ADDENDUM

ADDENDUM NO.: #02

DATE: 02/08/2024

PROJECT: Woodhouse Ford Pro: Building Improvements

**FLOOR PLAN -
 PLUMBING - WASTE
 AND VENT RISER**

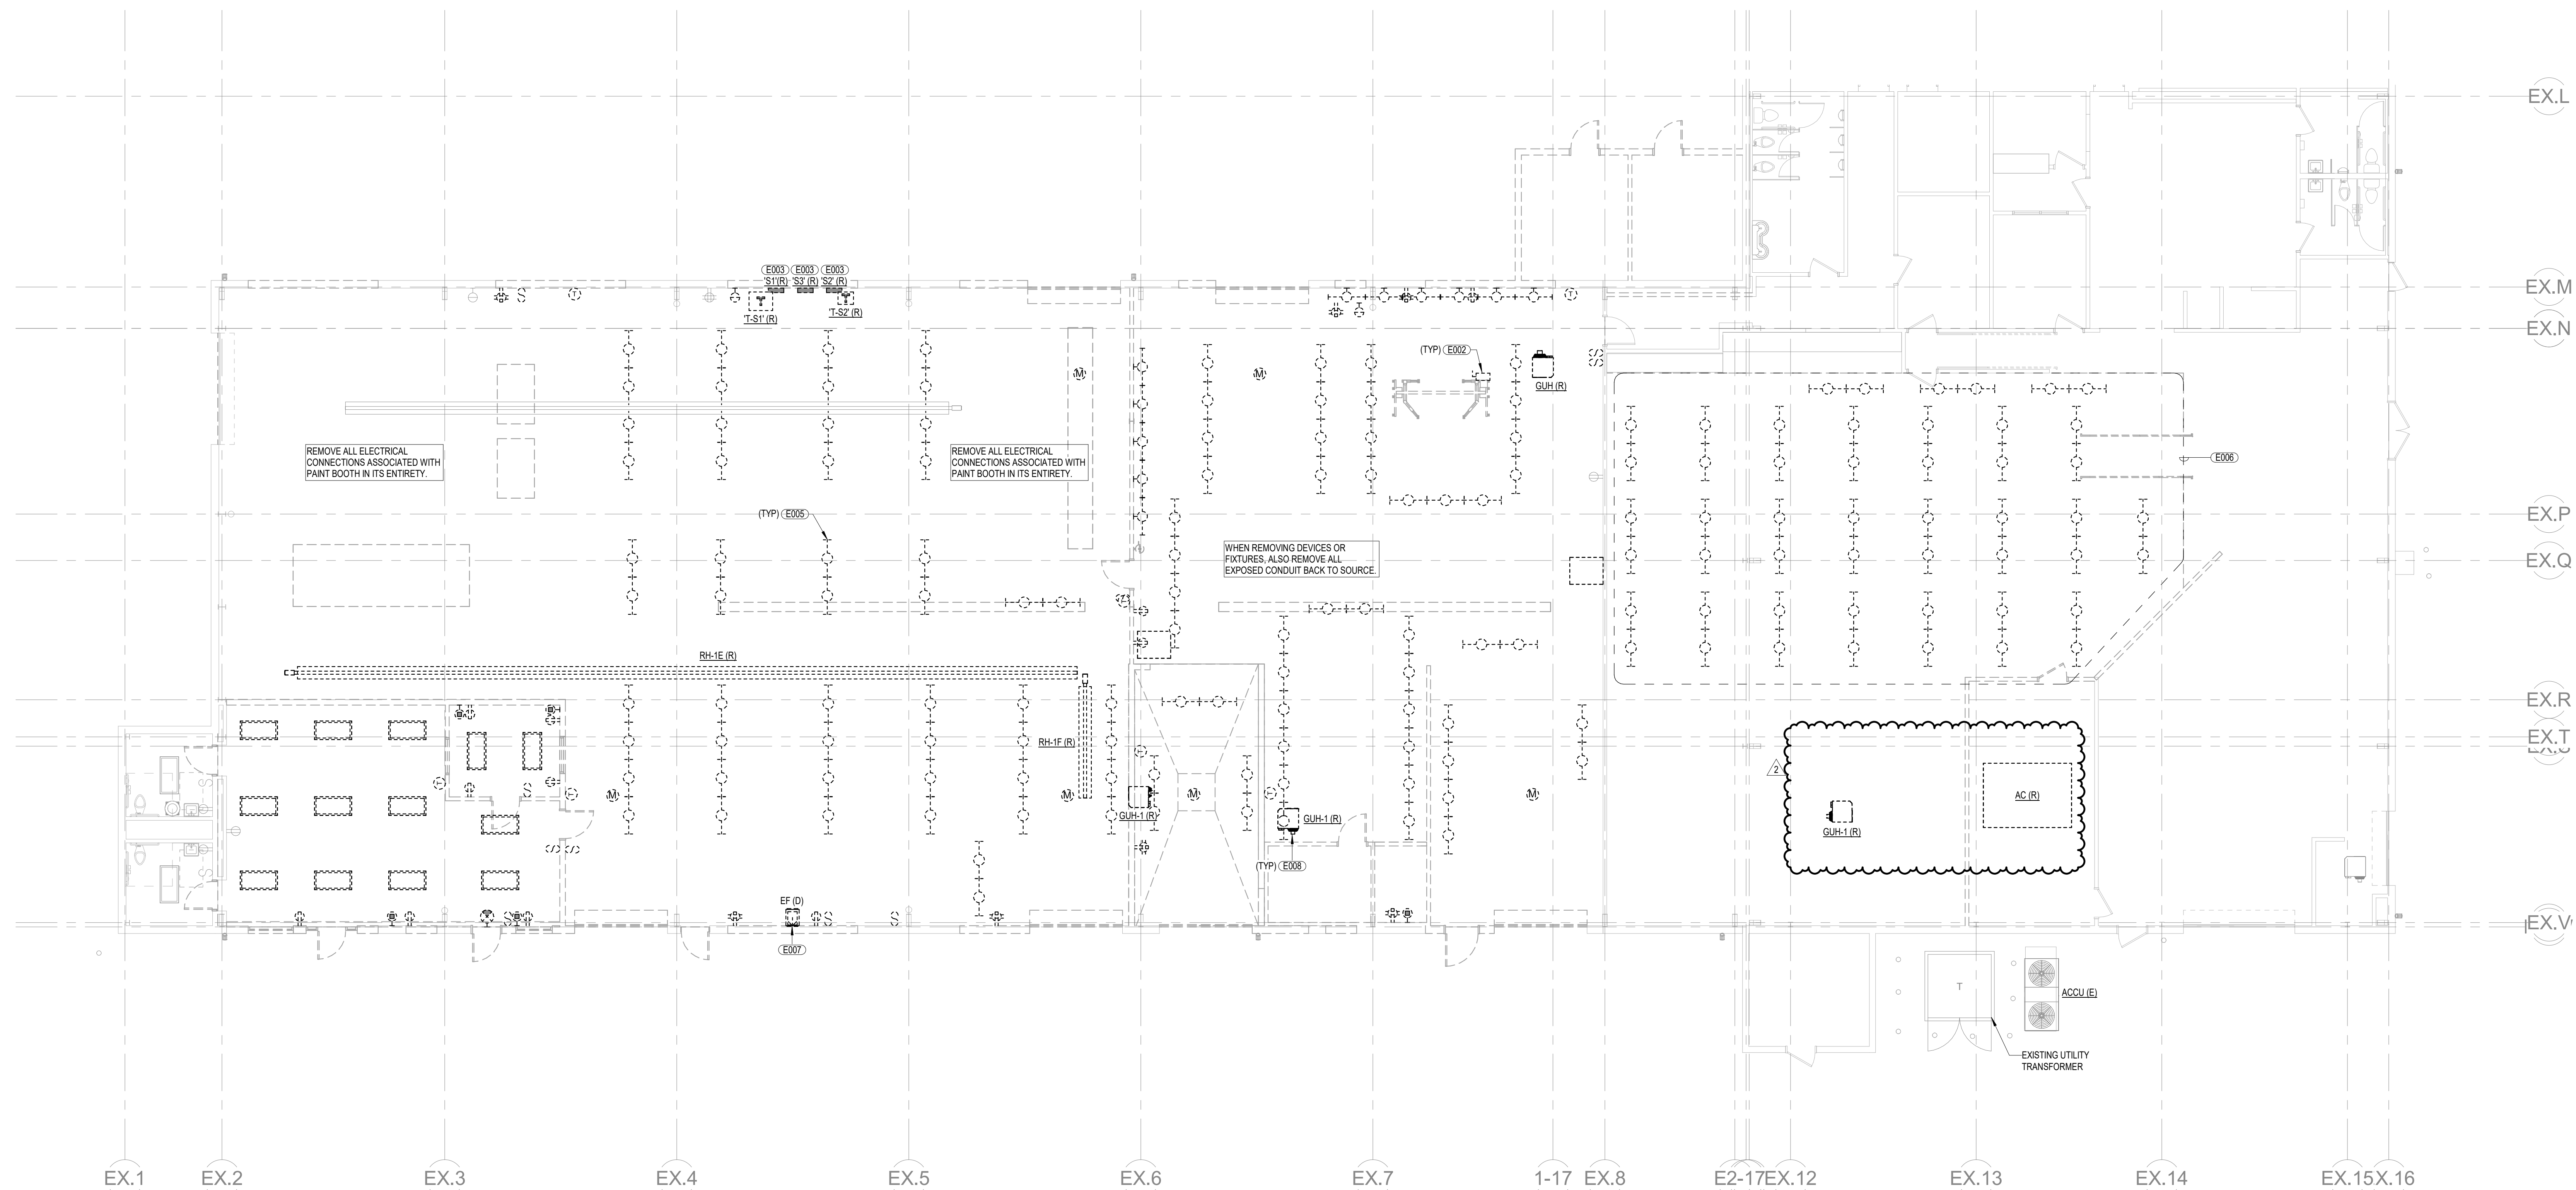
- a. Revise oil waste connections.
7. Sheet M4.1 – MECHANICAL SCHEDULES
 - a. Remove zone damper schedule.
 - b. Add VFD-RTU-1
8. Mechanical Specifications:

1 FIRST FLOOR - LIGHTING - AREA C
1/8" = 1'-0"

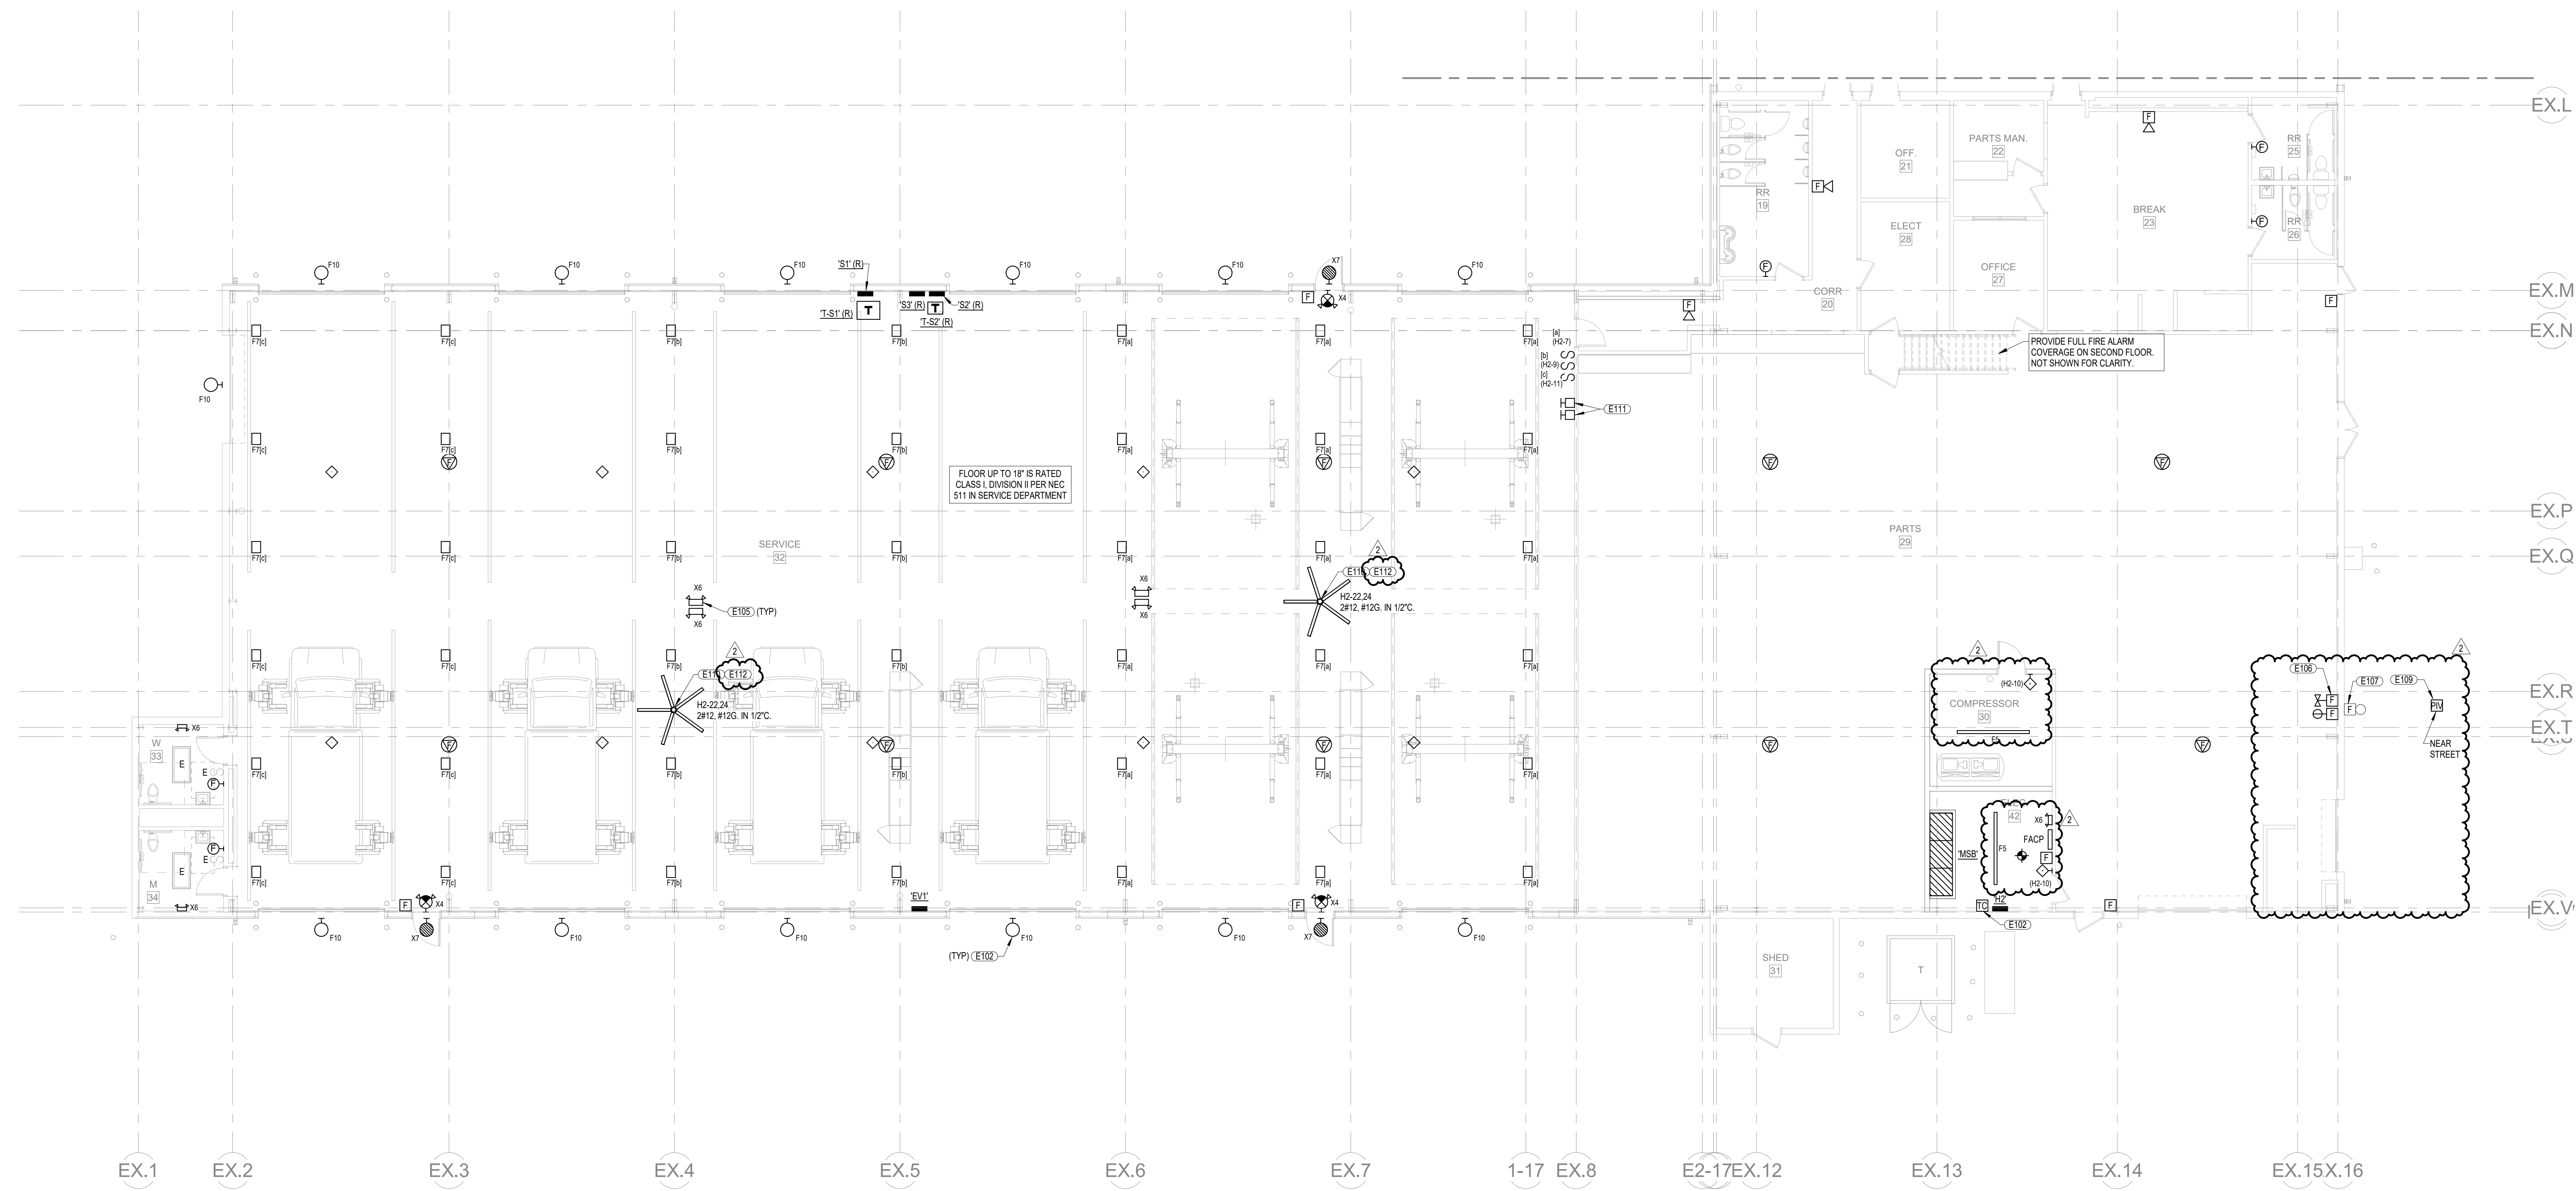
4. Sheet E1.3 – FLOOR PLAN – LIGHTING – AREA C
 - a. Add lighting to electrical and compressor rooms.
 - b. Revise fire alarm connections.
 - c. Add keynote.
5. Sheet E2.1 – FLOOR PLAN – POWER – AREA A
 - a. Add connection to VFD.
6. Sheet E2.2 – FLOOR PLAN – POWER – AREA B
 - a. Revise power connections at tire changing area.
 - b. Add 220V receptacles.
7. Sheet E4.0 – ELECTRICAL SCHEDULES AND DIAGRAMS
 - a. Update mechanical connection schedule.
8. Sheet E4.1 – ELECTRICAL PANEL SCHEDULES
 - a. Revise panel schedules.
